**NSLPP MEETING HELD ON 07/12/2022****Attachments:**

ADDRESS/WARD: 45 Thomas Street, McMahons Point**APPLICATION No:** DA72/22

PROPOSAL: Demolition of existing structures, removal of five (5) trees, construction of a 3 storey dwelling house and associated civil and landscaping works (including new driveway crossover)

OWNER: D Krawitz**APPLICANT:** B Brennan**AUTHOR:** Miguel Rivera, Senior Assessment Officer**DATE OF REPORT:** 24 November 2022**DATE LODGED:** 10 March 2022**RECOMMENDATION:** Approval

Figure 4: first floor

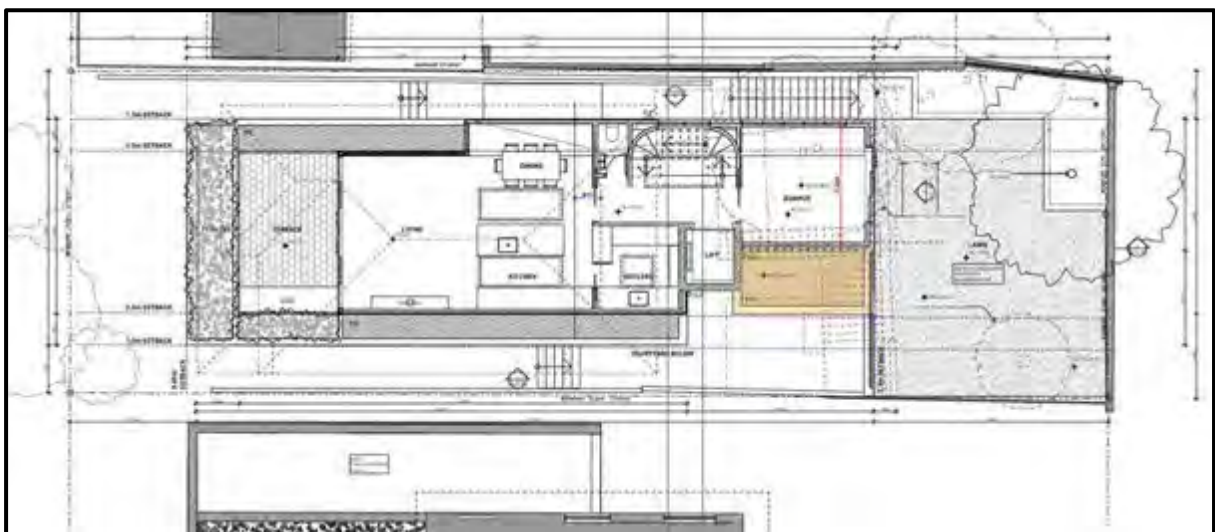
14 November 2022	<p>Council's Assessment Officer contacted the Applicant's Architect – advising them of first floor rumpus room and intention to reduce its dimensions and increase setback from the southern boundary.</p> <p>The Applicant provided amended plans via the Planning Portal that reduce the rumpus room and increase setback from the southern boundary. In light of the extent of changes and the improved outcome presented by the amended design, the revised plans did not require neighbour notification.</p>
------------------	---

The revised design only entails a reduced footprint of the first floor rumpus room at the rear of the site, which has a greater and improved setback from the southern boundary. This change was in direct response to the potential shadow impacts associated with this space. The amended proposal is not considered to have additional or greater impacts compared to the original design in terms of views or streetscape impacts. Therefore, re-notification was not required in accordance with Council's Community Participation Plan.

Figure 5: West (front) elevation

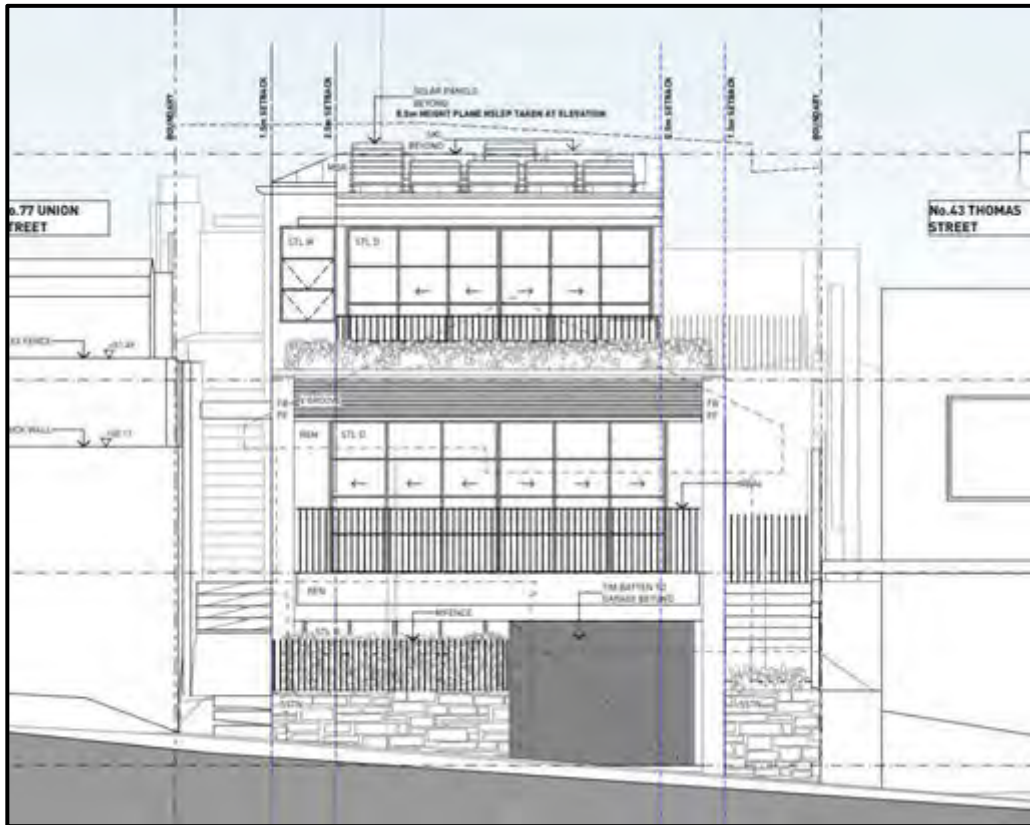
Whilst the rendered finish is appropriate, the extensive glazed openings are uncharacteristic within the conservation area. It is recommended that the proposal be revised to increase the solid to void ratio and reduce the amount of glazed area by at least one third (33.3%) on all levels. At the first floor level at least, the introduction of a central column is recommended. All the glazing should be set-in from the side boundaries. The windows in the ground floor level will need to be realigned with the revised window openings above. It is also recommended that the black framed windows utilise a neutral colour.

It is noted that the proposed 2-car garage will replace an existing single car garage currently built to the street alignment. There is potential to recess the garage entry albeit for a nominal amount of 0.2m approximately, and to reduce the size of the garage door to minimise the dominant impact of a garage element.

- C1. The architectural plans must be amended as follows:
- The glazed openings facing Thomas Street must be reduced in area by at least one third (33.3%) to express an increase in the solid to void ratios, particularly at the ground and first floor levels.
 - The steel framed windows and doors facing Thomas Street must have a neutral colour.
 - The proposed garage door must be recessed in area by 200mm to reduce the overall size of its opening and to reduce its visual impact on the Thomas Street streetscape

Combined living/dining/kitchen room of No. 43 Thomas Street – north-facing windows indicated by yellow arrows, west-facing windows indicated by red arrows

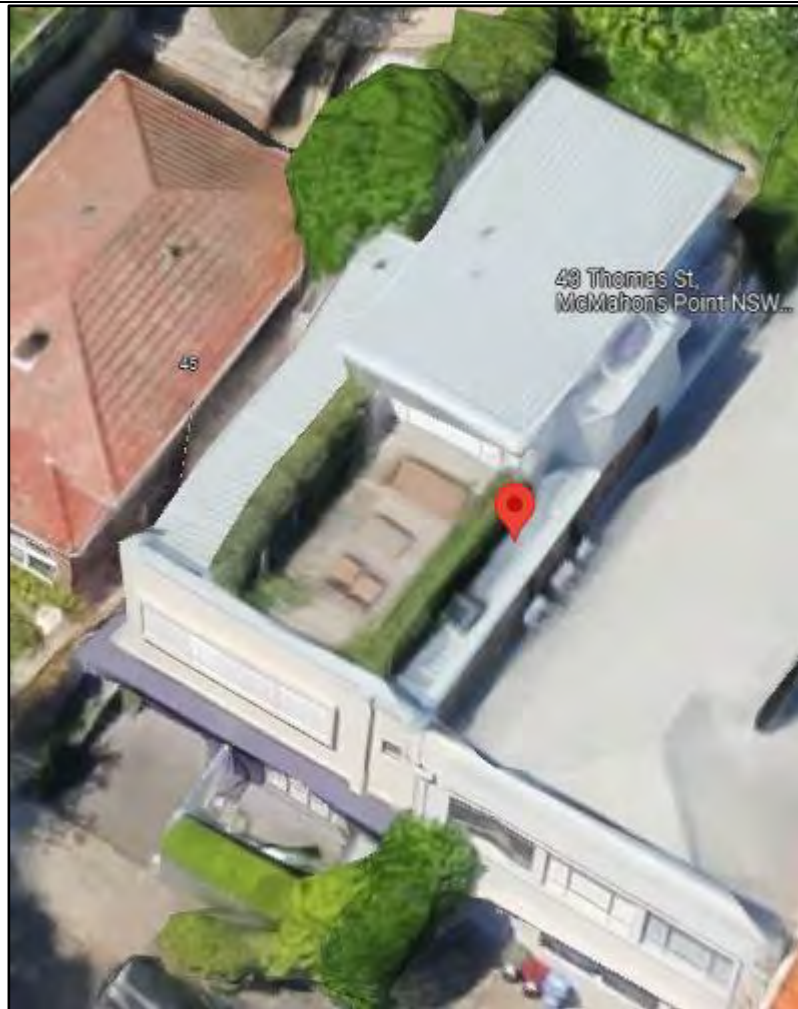
The north-facing windows within a combined living/dining/kitchen room of the dwelling at No. 43 Thomas Street are mostly impacted by the additional overshadowing created from introducing a split-level dwelling house within the subject site (in replacement of a single storey building). It is noted, however, that the combined living/dining/kitchen room features west-facing windows in the living room that provide ample solar access to this room. The design of this space ensures that a minimum three (3) hours of sunlight is accessed and that the above solar access requirement is achieved.

The rear private open space of No. 43 Thomas Street will be affected by the proposed development. This space is already challenged in terms of solar access given its aspect, sunken location and existing vegetation and structures that limit light penetration. Whilst the DCP requirement cannot be achieved for this space, the amended design does feature additional setbacks (from the southern boundary) for the first floor rumpus room, which provides some solar access to this space. A review of overshadowing impacts indicated that a portion (at least 30%) of the rear private open space of No. 43 Thomas Street will receive two (2) hours of solar access during mid-winter.

Rumpus room (first floor) side setback from southern boundary

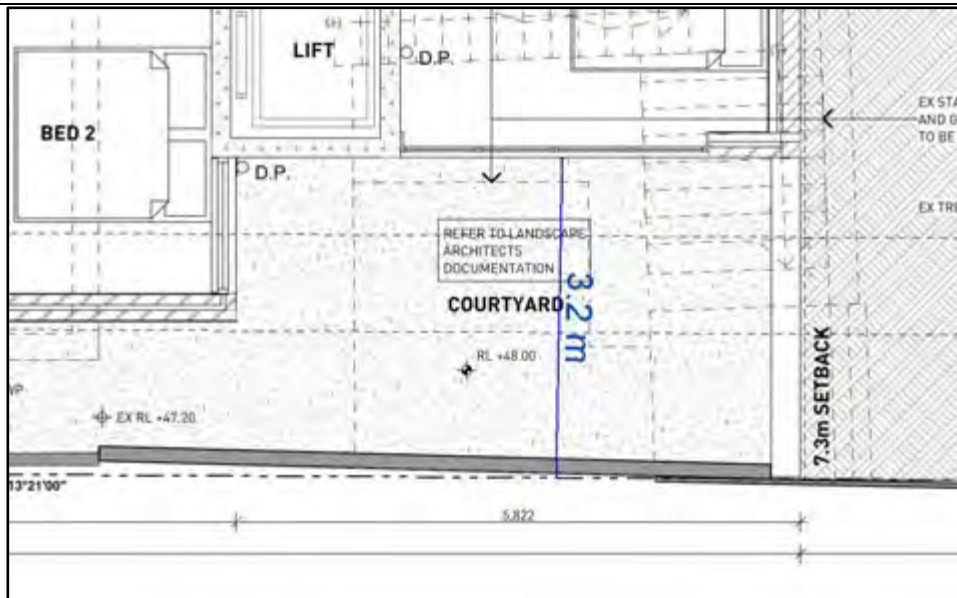
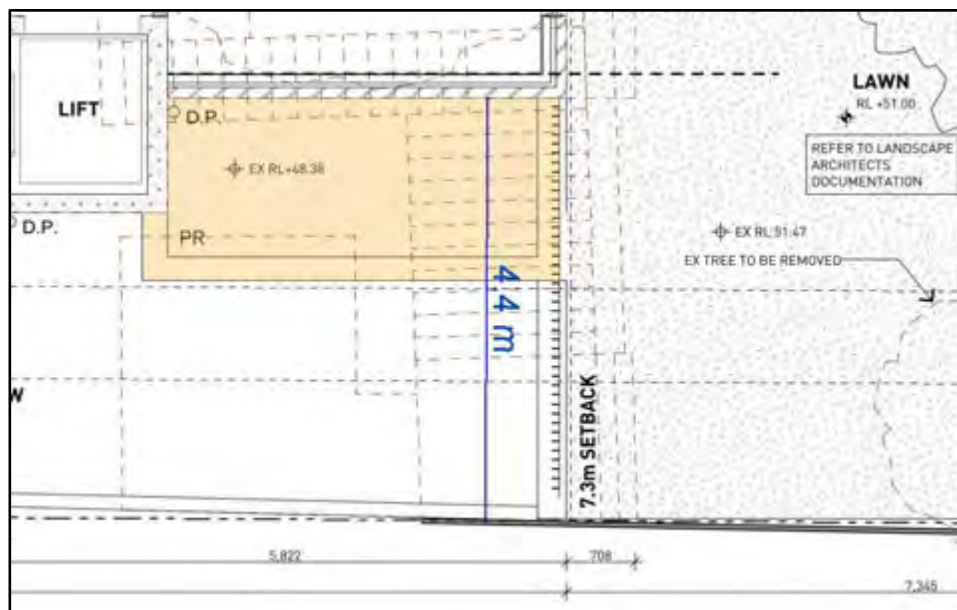
<p>Setback – side</p> <p>1st storey (up to 4m): min. 0.9m 2nd storey (up to 7m): min. 1.5m</p>	<p>Yes – all floors</p>	<p>The proposed development features minimum side setbacks of:</p> <p><u>First floor</u></p> <ul style="list-style-type: none"> • 1.5m (northern boundary) • 2.5m (southern boundary) <p><u>Lower and upper ground floors</u></p> <ul style="list-style-type: none"> • 1.5m (both boundaries) <p>These setbacks are fully compliant with the minimum requirements. It is further noted that the design features sufficient articulation and modulation. In particular, the visual bulk and interruption of the southern elevation is facilitated by additional southern side setbacks of the ground floor (bedroom 3) and the first floor rumpus room, which are 3.2m and 4.4m, respectively.</p>
